Road Safety Audit Report

**Incorporating
Stage 1 Completion of Preliminary Design; and
Design Organisation Response to items raised.**

Proposed Access off and Highway works along the B2102, Bird in Eye Hill in Uckfield

Job no	RSA-20-053	Issue no	2	Date	August 2020
Prepared by	JJF	Verified by	FB	Approved by	JJF
Filename and Path	Fenley/Road Safety Audits/RSA-20/RSA-20-053-2

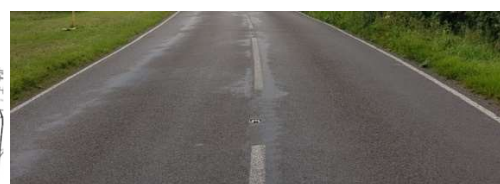
A.1	LOCAL ALIGNMENT
A.1.1	PROBLEM
Location:	Proposed access
Summary:	Vehicles may approach Bird in Eye Hill at inappropriate speeds
Acc Type:	Junction overshoot
<p>The application site is currently set at a level above the adjacent Bird in Eye Hill with the existing access rising gradually away from the main carriageway. The proposals relocate the existing access to Bird in Eye Farm in order to serve a proposed development of 300 residential dwellings as well as two existing dwellings outside of the application site. The scheme drawings do not identify the gradient of the proposed carriageway at this stage, however, the land in proximity appears to be approximately 2 to 2.5 metres higher than the level of the existing carriageway. A gradient in excess of 1 in 20 on approach to a simple priority access could lead to junction overshoot type incidents.</p>	
RECOMMENDATION:	
It is recommended that the access road is set at a gradient shallower than 1 in 20 on approach to the B2102.

Location Plan:  	
DESIGN ORGANISATION RESPONSE provided by Bellamy Roberts on the 4 th August '20 following formal issue of this Stage 1 Road Safety Audit on the 3 rd August '20	
<p>The proposed access will be designed with 1 in 20 or slacker gradient than in accordance with standards with the land either side, graded up away from the carriageway at an appropriate gradient.</p>	
A.2	GENERAL
A.2.1	PROBLEM
Location:	Bird in Eye Hill
Summary:	Drivers approaching the proposed traffic island may not become aware of the feature at a safe distance
Acc Type:	Vehicle loss of control
<p>In proximity of the proposed access, Bird in Eye Hill is derestricted, subject to the 60 mph national speed limit and accommodates a number of bends in proximity of the proposed access. The</p>

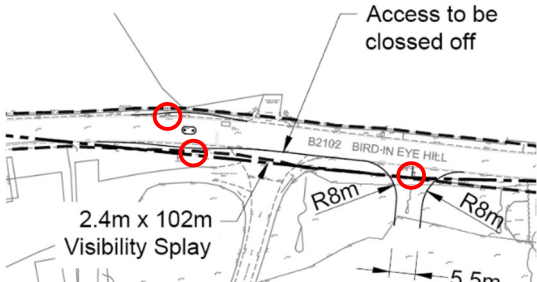
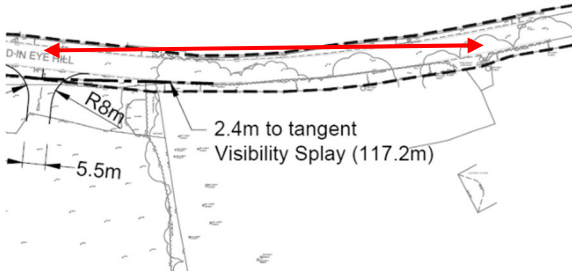
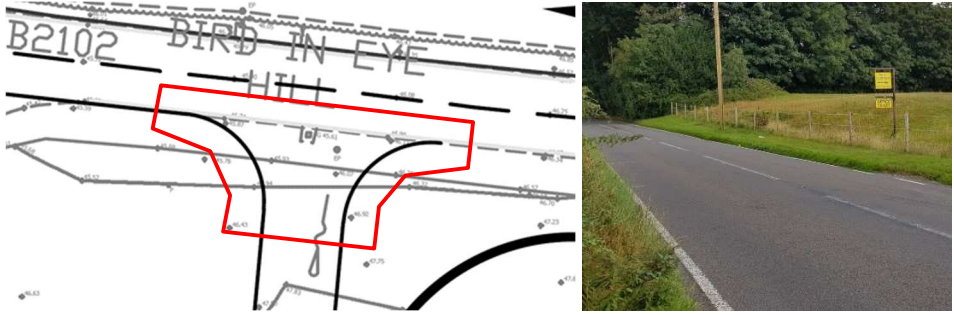
Summary: Existing Telegraph / Electric pole will become an obstruction to vehicles

Signage and telegraph poles are situated within the existing verge along Bird in Eye Hill. The proposals relocate an existing access approximately 30 metres to the east which is to serve the existing dwellings as well as the proposed development of 300 dwellings. However, a telegraph / electric pole is situated in the proposed bell mouth access in the path of vehicles and will be an obstruction.

It is recommended that the telegraph / electric pole is relocated, and the access is free of obstructions.

Location Plan:  	
DESIGN ORGANISATION RESPONSE provided by Bellamy Roberts on the 4 th August '20 following formal issue of this Stage 1 Road Safety Audit on the 3 rd August '20	
All existing street furniture, utility covers and gullies will be reviewed during the detail design of the scheme.	
A.2.3	PROBLEM
Location:	Proposed Access and Bird in Eye Hill
Summary:	Existing road gully will be within the path of vehicles
Acc Type:	Loss of control
<p>Bird in Eye Hill is cambered with surface water falling to the channels either side of the carriageway where road gullies are present. During the site visit associated with this Audit, a number of gullies in proximity to the proposed works were observed to be blocked and therefore ineffective. The proposals that introduce a traffic island to the west of the proposed access, widen the Bird in Eye Hill carriageway where a gully is present either side of the road. No details of the proposed surface water drainage have been provided at this stage; however, an insufficient network is likely to result in ponding during inclement conditions which increases the likelihood of loss of control type incidents. Furthermore, a road gully within the path of a vehicle could give rise to loss of control type incidents particularly for two wheeled vehicles and vehicles undertaking a braking manoeuvre.</p>

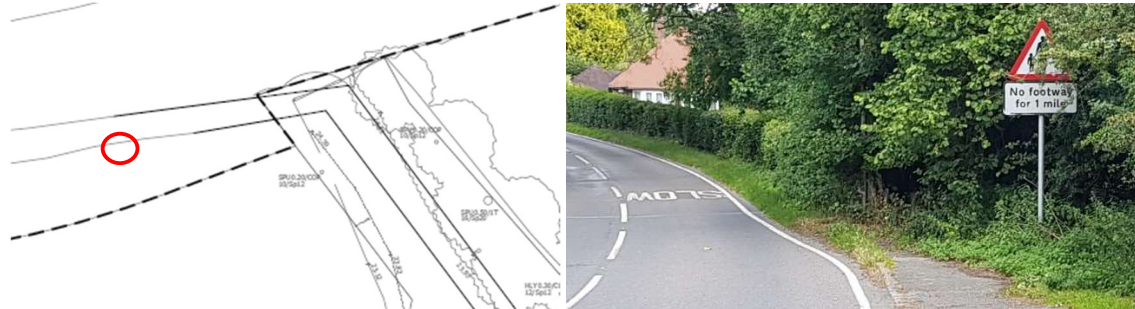
Summary: Existing signage will become an obstruction to pedestrians

In proximity of the proposed footway cycleway access the verges of Bird in Eye Hill accommodates a number of telegraph / electric poles and road signs. The proposals introduce a connection between Bird in Eye Hill and the local pedestrian network, to the west of the proposed access via footpath through a wooded area. An existing telegraph / electric pole is situated just to the west of the proposed connection will be situated central to the footway and become an obstruction to pedestrians that could force one to enter the carriageway suddenly raising the risk of vehicle collisions with pedestrians.

It is recommended that the telegraph pole is relocated.

DESIGN ORGANISATION RESPONSE provided by Bellamy Roberts on the 4 th August '20 following formal issue of this Stage 1 Road Safety Audit on the 3 rd August '20	
All existing street furniture, utility covers and gullies will be reviewed during the detail design of the scheme.	
A.4.2	PROBLEM
Location:	Proposed footpath connection, Bird in Eye Hill
Summary:	Cyclists are likely to utilise the proposed footpath
Acc Type:	Cyclist and pedestrian collisions
<p>Bird in Eye Hill benefits from a footway along the southern side that terminates just to west of the gated access to the application site. The scheme drawing provided with the Audit Brief illustrates that a footpath connection is proposed at this location which is approximately the same width as the existing footway, however, as identified within the Transport Assessment associated with the scheme, a 3.0-metre wide shared use footway / cycleway link is to be provided. The proposed link is considerably shorter than following Bird in Eye Hill and as such, it is highly likely that cyclists will utilise the link. Should the link be insufficient to accommodate a high number of pedestrians and cyclists, there could give rise to cyclist-pedestrian collisions.</p>
